APPEAL SUMMARY

Appeal ID: 18957	Project Address: 820 SE Alder St
Hearing Date: 2/6/19	Appellant Name: Iain MacKenzie
Case No.: B-009	Appellant Phone: 5032200668
Appeal Type: Building	Plans Examiner/Inspector: Maureen McCafferty
Project Type: commercial	Stories: 10 Occupancy: R-2, A-2, A-3, S-2, B Construction Type: Type I-B
Building/Business Name: Alder.9	Fire Sprinklers: Yes - Throughout
Appeal Involves: Erection of a new structure	LUR or Permit Application No.: 18-261126-CO
Plan Submitted Option: pdf [File 1] [File 2]	Proposed use: Residential / Retail

ALDER.9TH
820 SE ALDER ST.

1 LOBBY STAIR PLAN - LEVEL 00
3/8" = 1'-0"

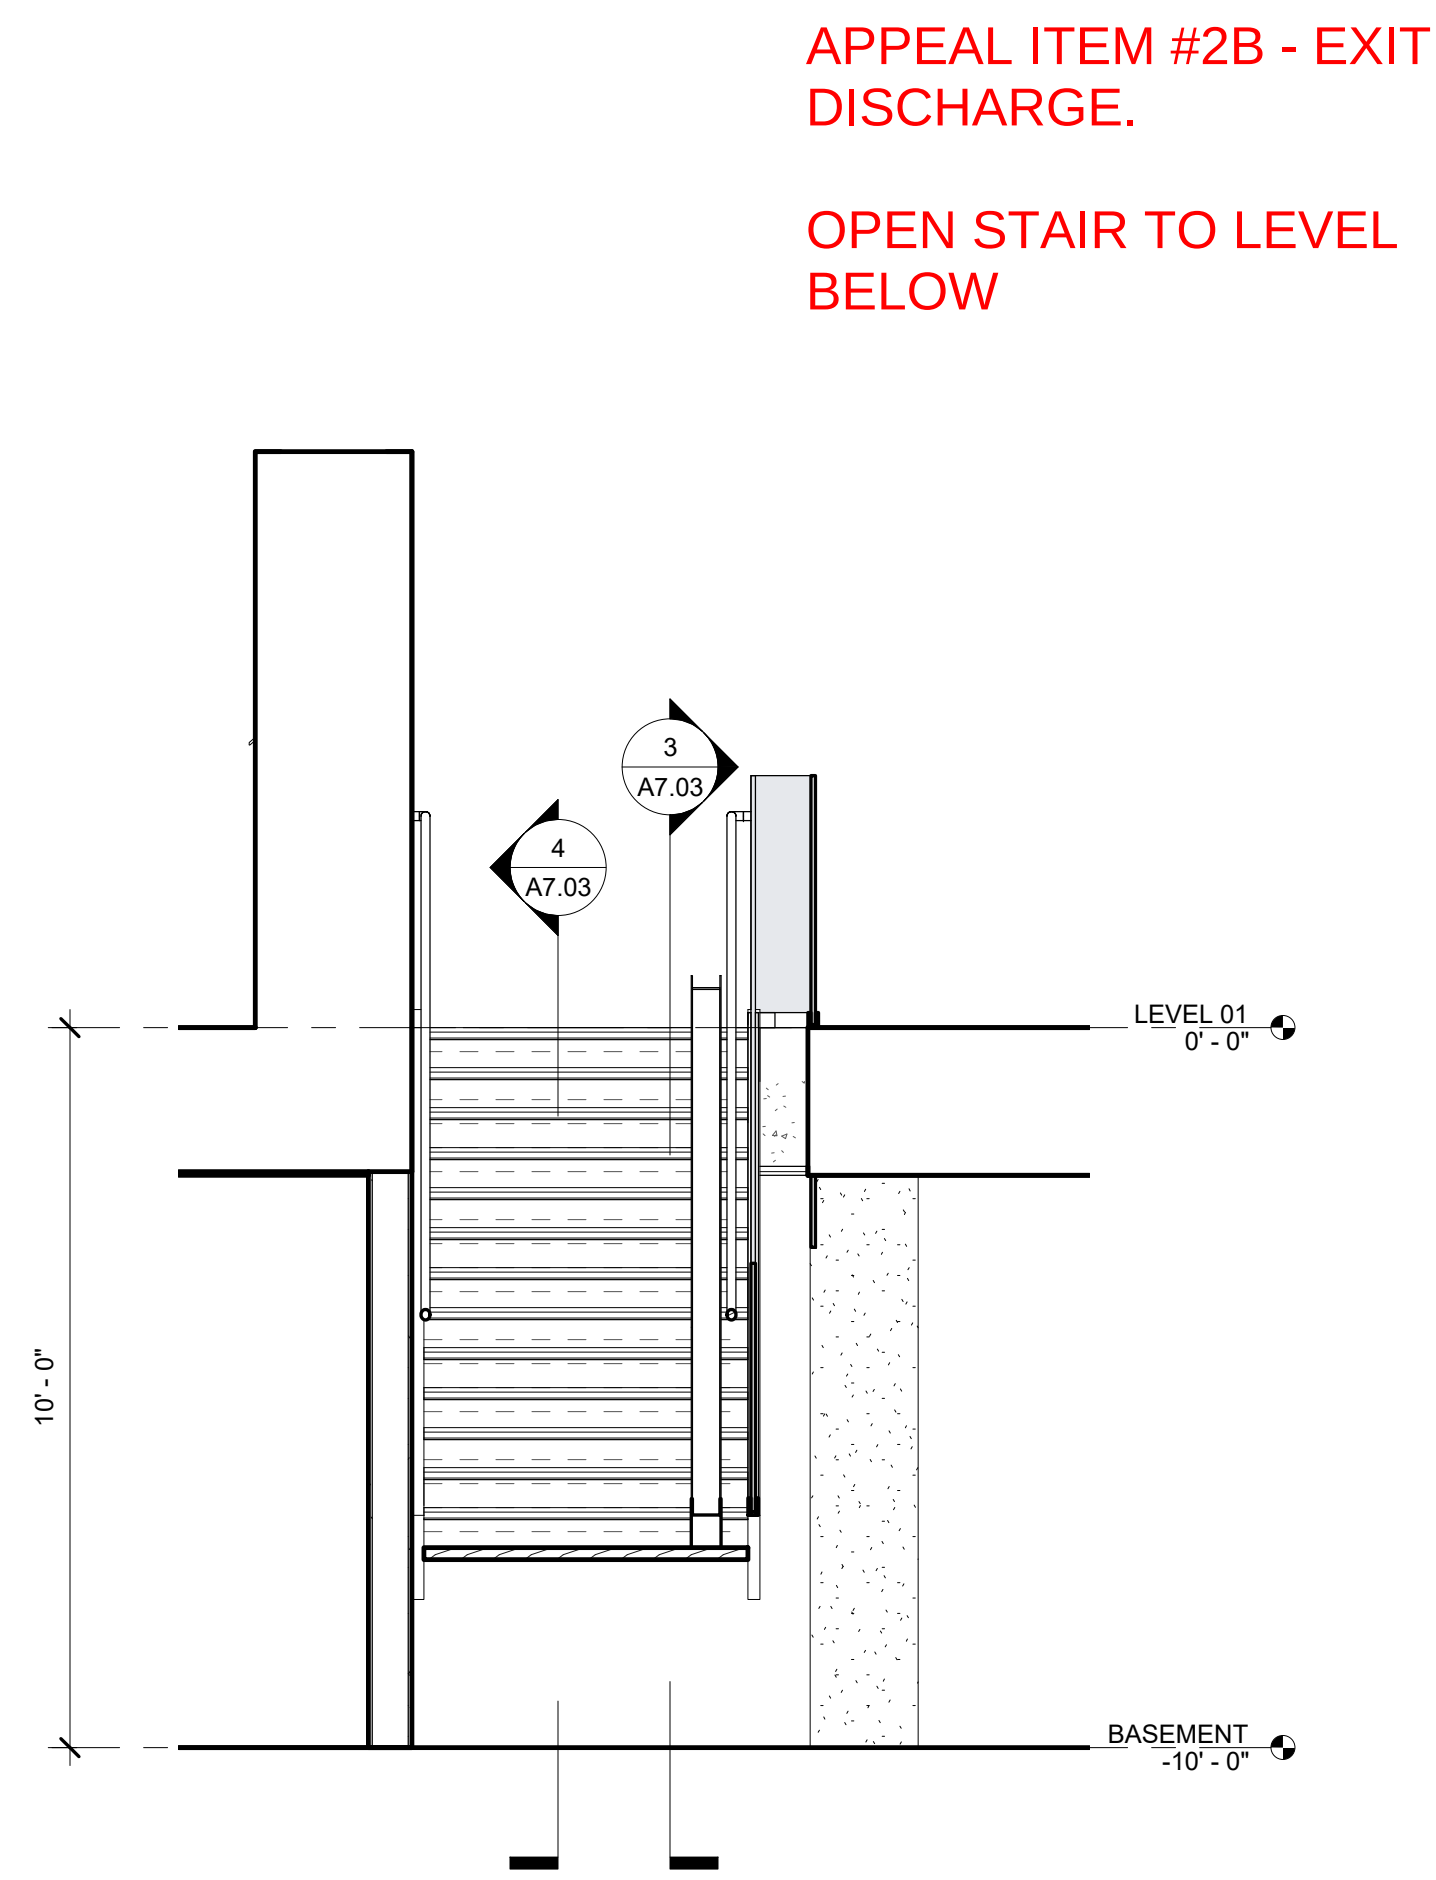
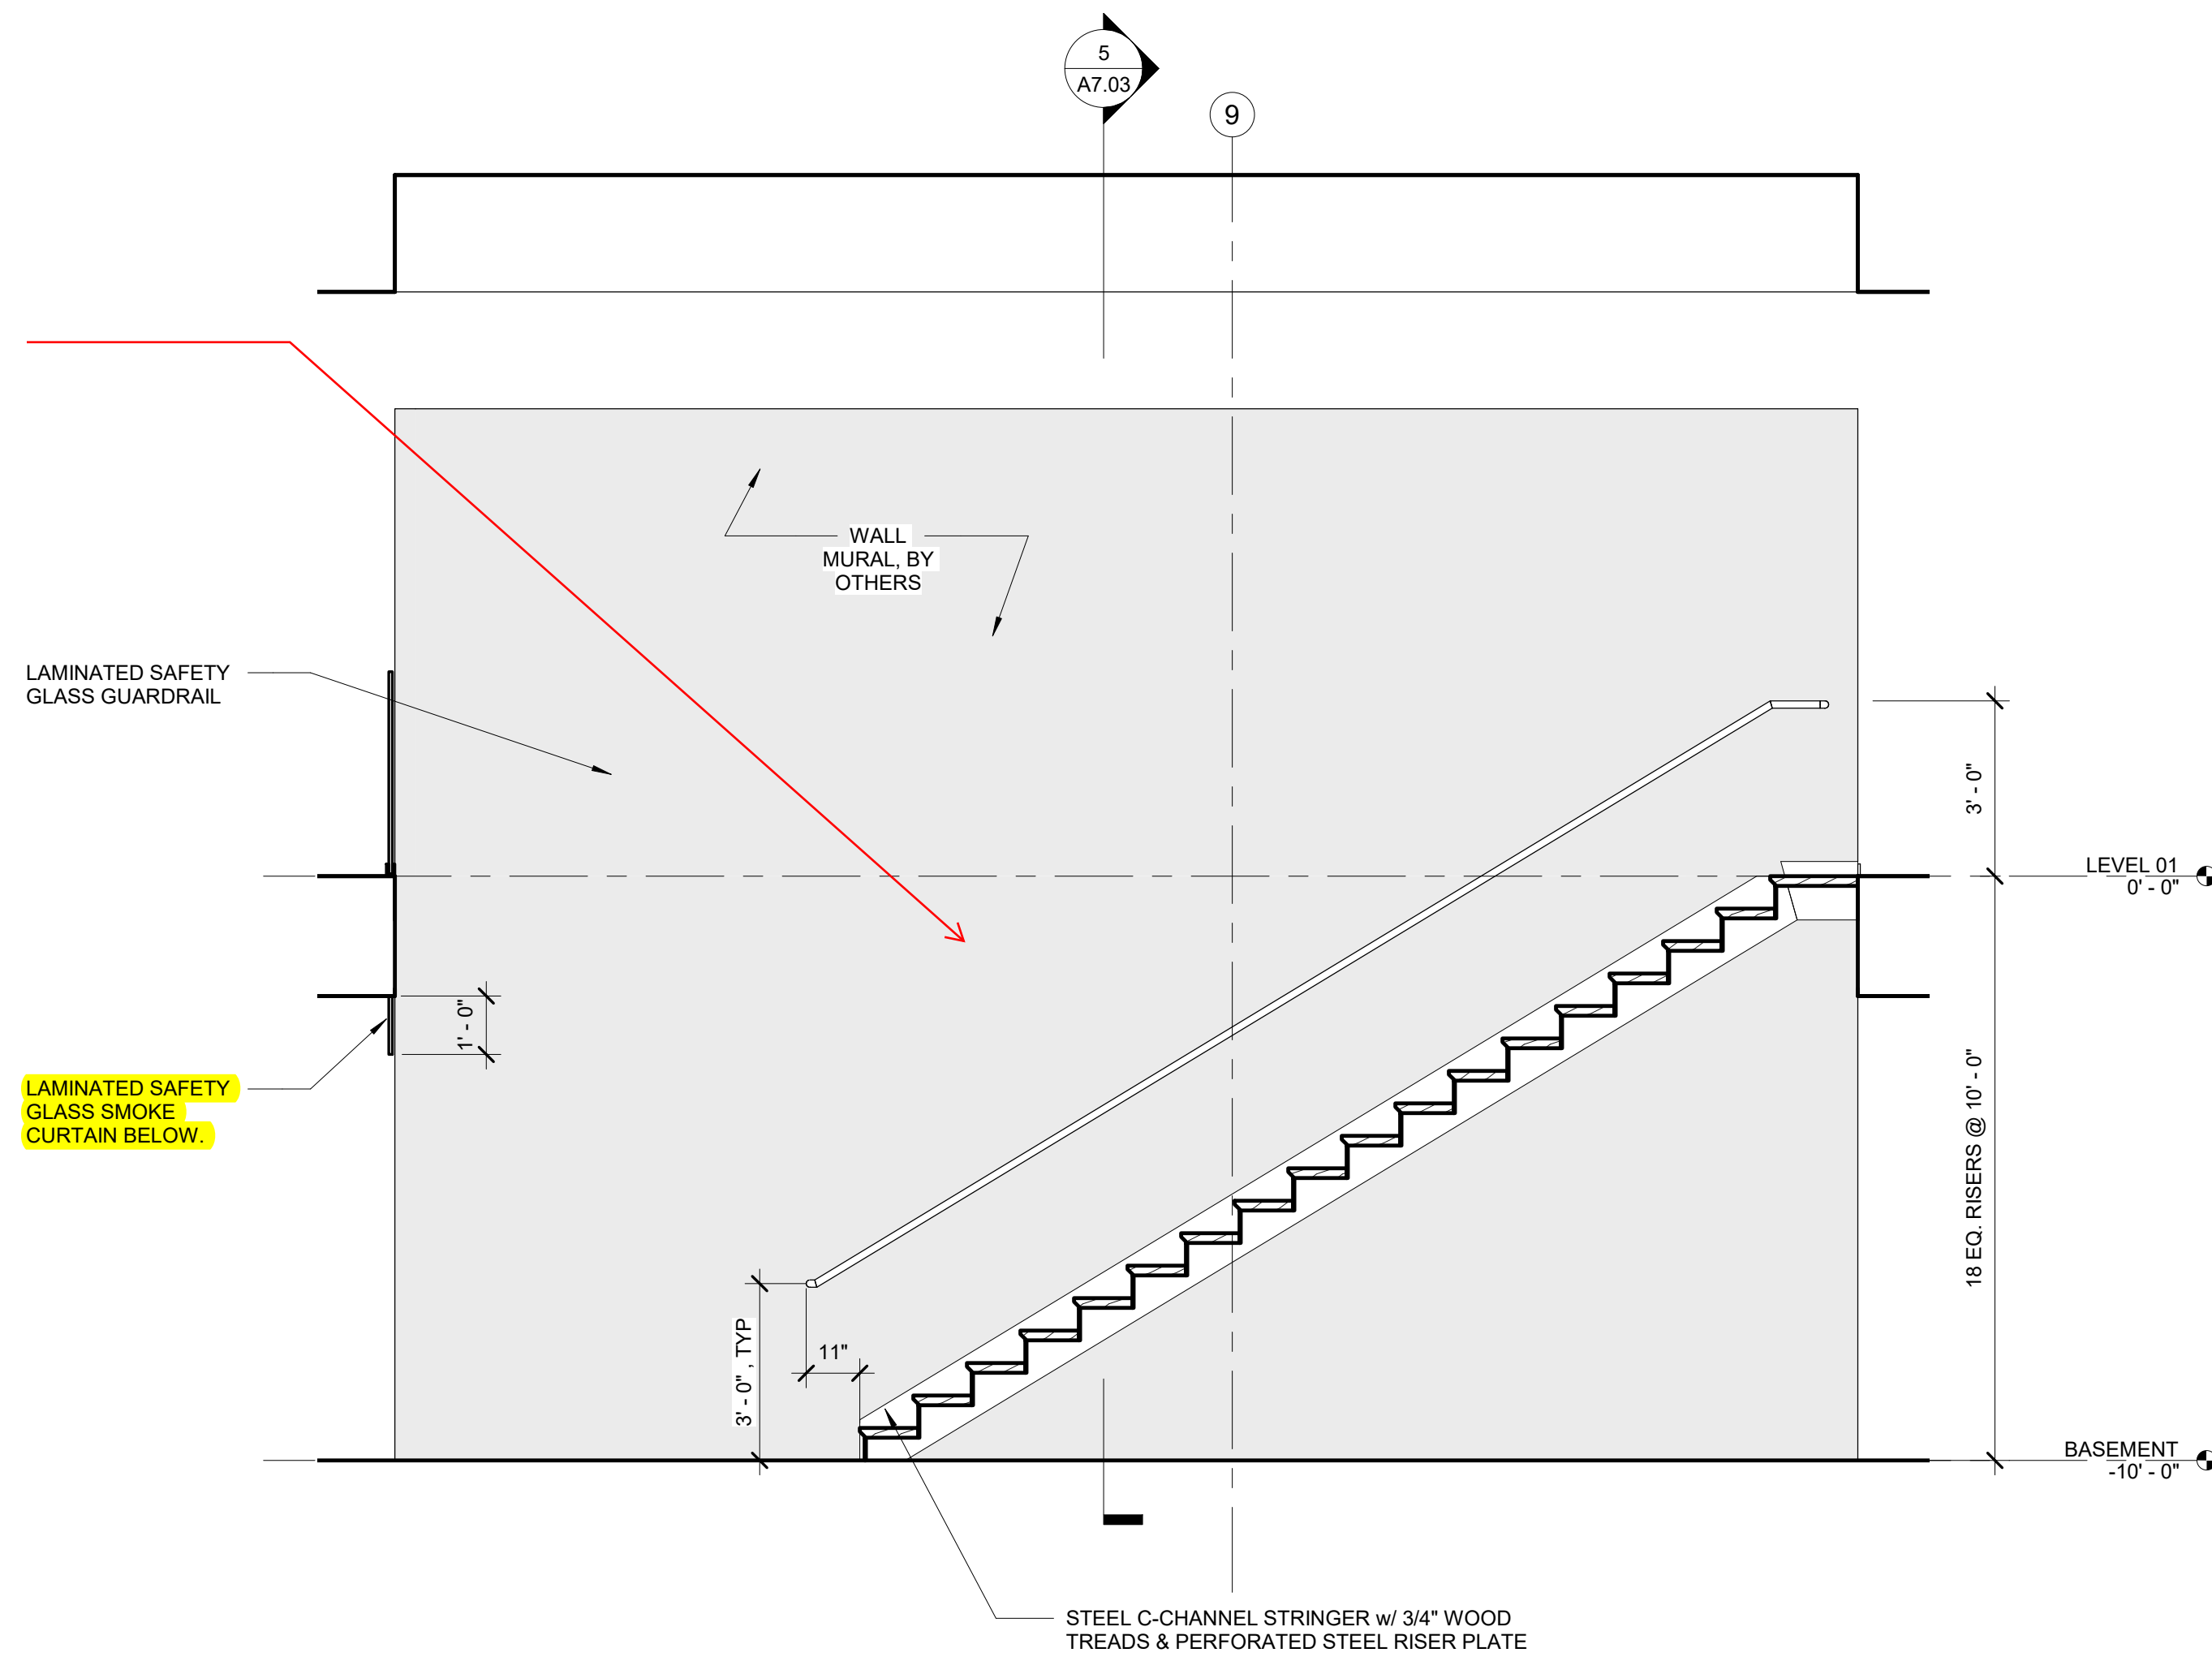
- b) The open stair connects the lobby to a small, low hazard space, which is separated from the rest of the basement by fire barriers. All spaces are fully sprinkled. Should a fire break out in any other part of the basement it would be prevented from spreading to the dog wash by the combination of sprinklers and fire barriers.

In the event of a fire in the dog wash room the opening in the level 1 slab is protected with laminated glass smoke curtains, which would prevent smoke from traveling from the dog wash room to the lobby.

RECESSED MAILBOXES AND PACKAGE STORAGE ROOM

APPEAL ITEM #2B - EXIT
DISCHARGE.

OPEN STAIR TO LEVEL
BELOW

2b. Separation of exit discharge from areas below: Granted as proposed.
